<b>Docket Number:</b>	19-SPPE-02
<b>Project Title:</b>	Walsh Data Center
<b>TN #:</b>	230307
<b>Document Title:</b>	WP LLC Responses to CEC Data Request Set 2
<b>Description:</b>	N/A
<b>Filer:</b>	Scott Galati
<b>Organization:</b>	DayZenLLC
<b>Submitter Role:</b>	Applicant Representative
<b>Submission Date:</b>	10/22/2019 8:24:41 AM
<b>Docketed Date:</b>	10/22/2019

# RESPONSE TO CEC STAFF DATA REQUEST SET 2 (68-71)

Walsh Backup Generating Facility (19-SPPE-02)

**WP, LLC'S RESPONSES TO CEC DATA REQUEST SET 2 (68-71)  
WALSH BACKUP GENERATING FACILITY (19-SPPE-02)**

# OVERALL UTILITY PLAN

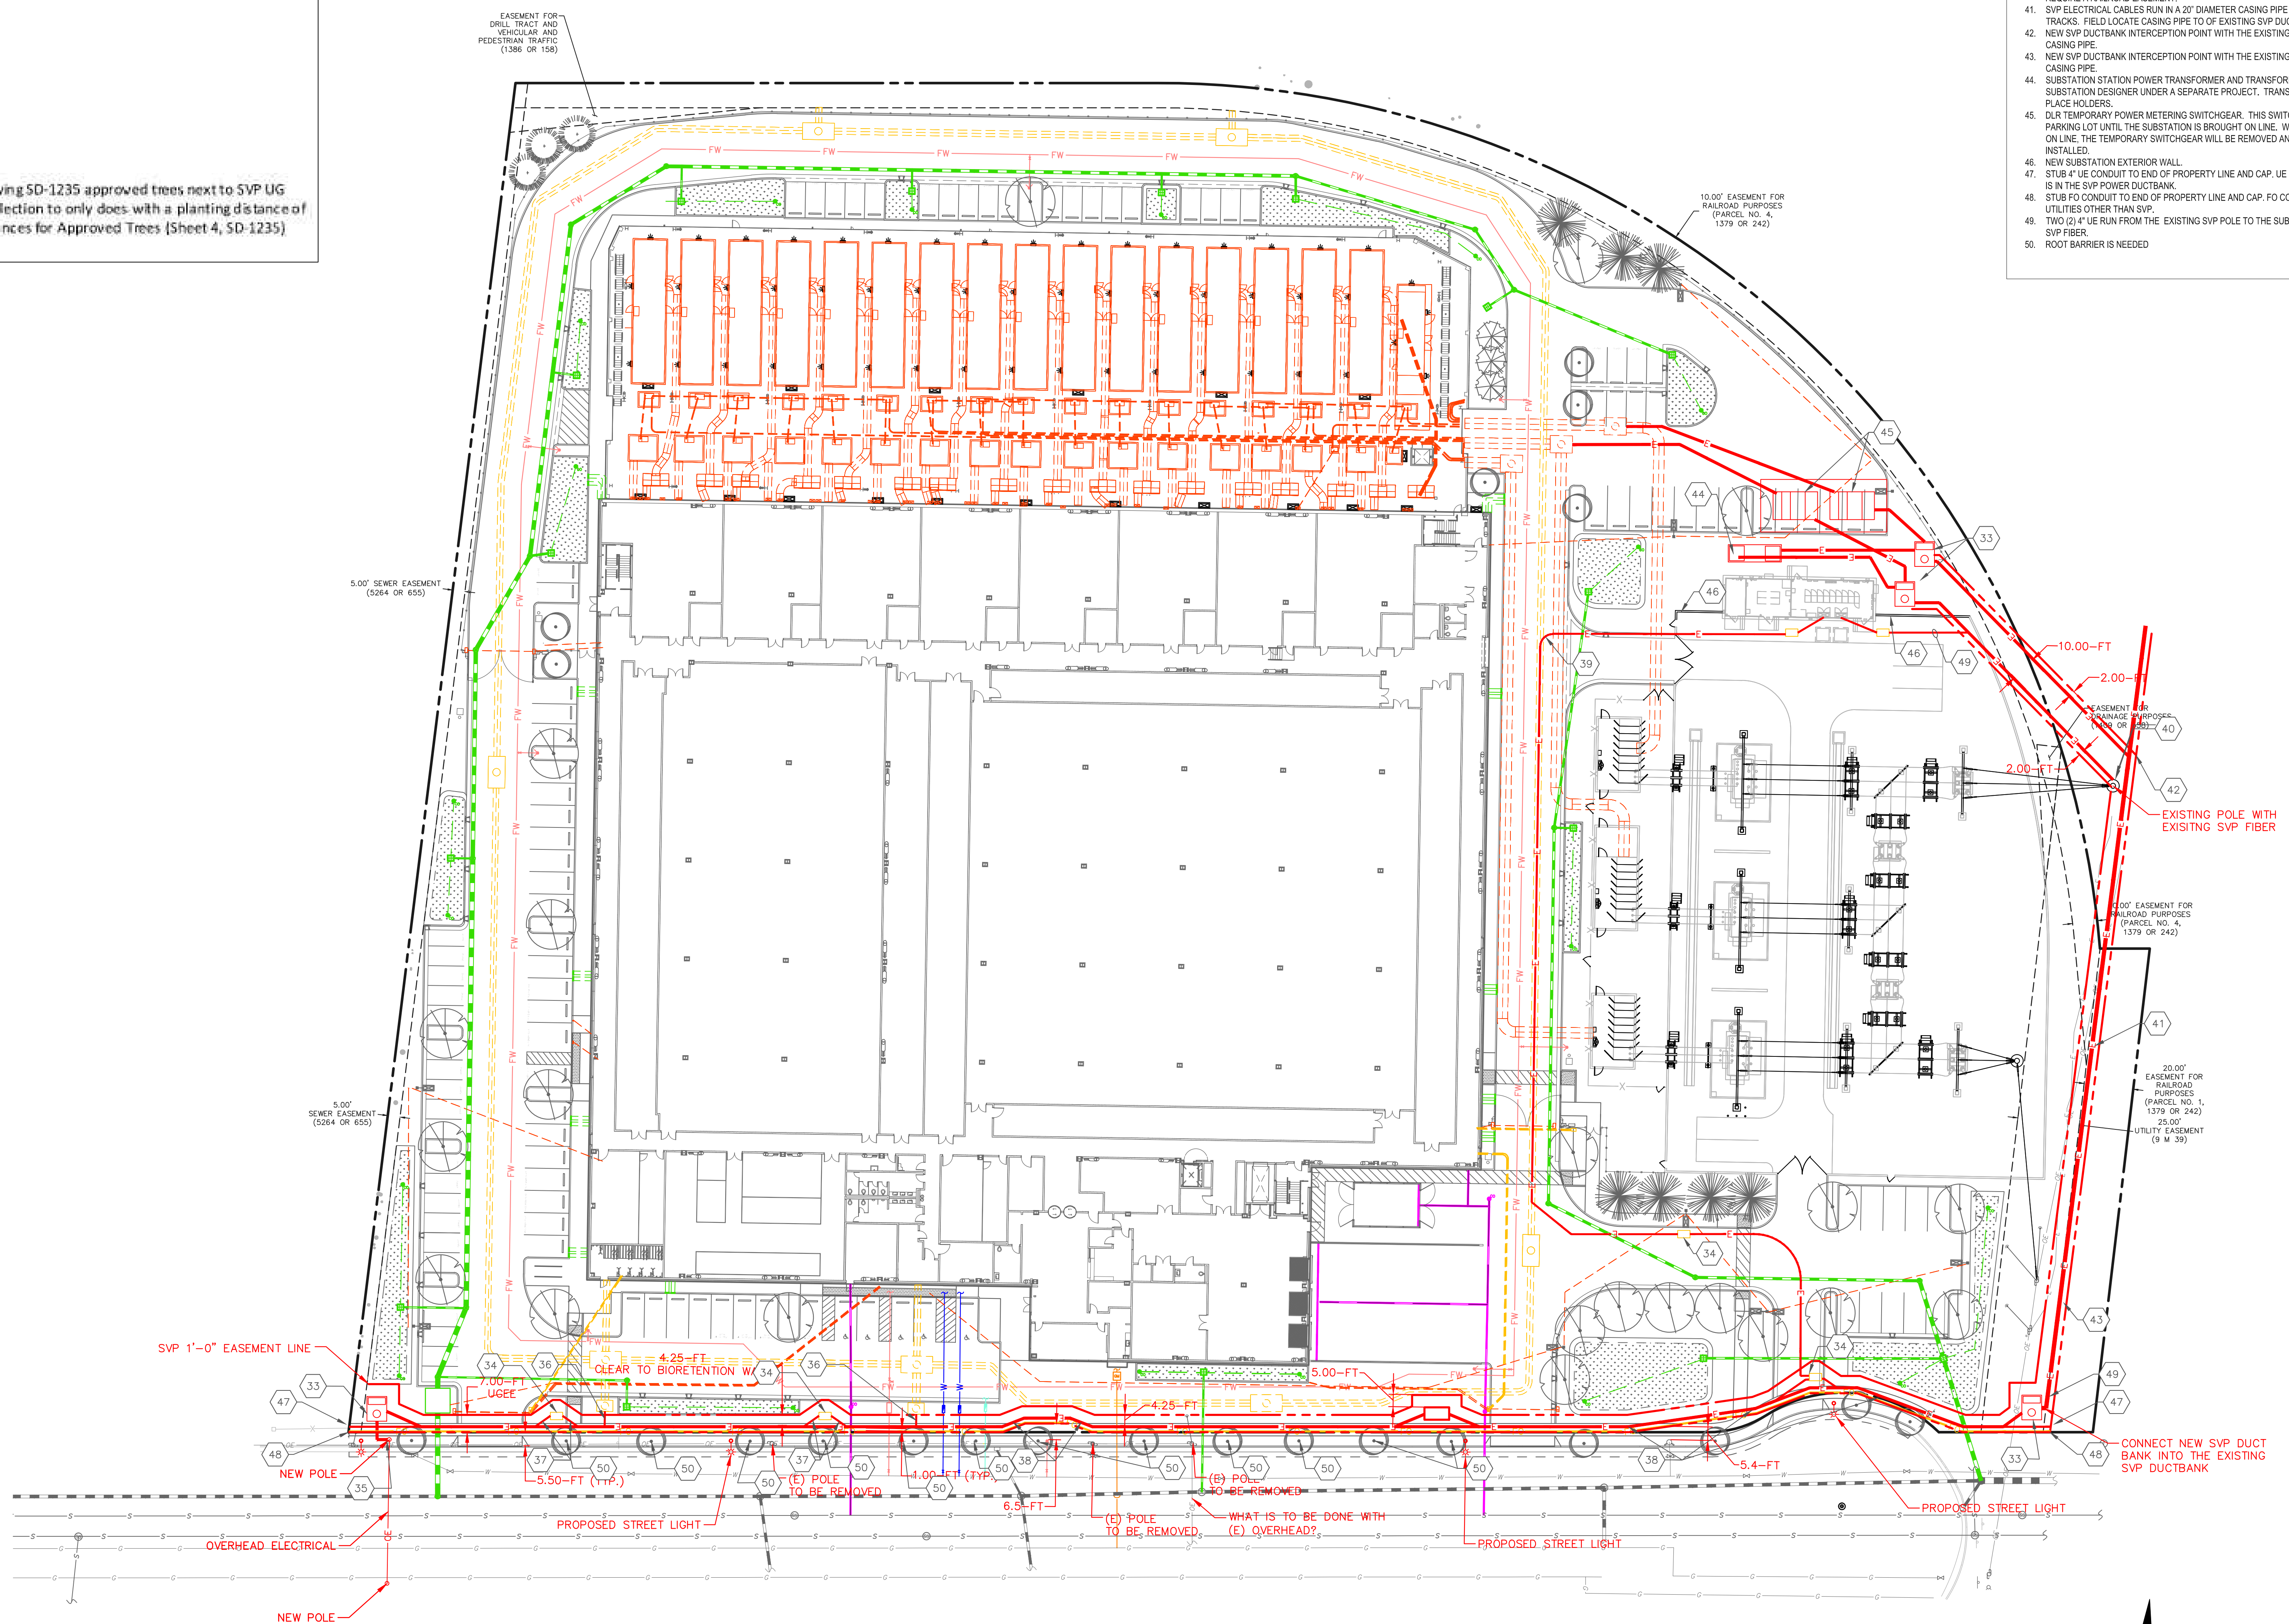
71. Please provide a detailed description and drawing of the proposed 60-kV transmission line route, possible interconnection points to the existing Silicon Valley Power system, and possible pole locations. Please provide a legend and label the drawing to show the proposed line route, pole locations, and existing transmission facilities.

As described in earlier responses to data requests, SVP will construct, own and operate the transmission lines that will bring electricity to the onsite substation. Attached is the best information we have been able to obtain as SVP has not yet designed the details that Staff requests in Data Request 71. WP, LLC believes that Staff does not need the detailed information to conduct a CEQA analysis. Unlike a traditional power plant, the CEC does not have jurisdiction over SVP's distribution lines as the first point of interconnection between the WBGF and the WDC, is the cabling between the WBGF and WDC building. For CEQA purposes a general description of the route is all that is necessary to determine, that with the mitigation incorporated into the project for potential impact associated with installation of transmission poles (cultural monitoring, etc.), potential impacts to the environment would be less than significant levels.

Appendix PD DR-71 includes a revised utility plan and other drawings responsive to this request.
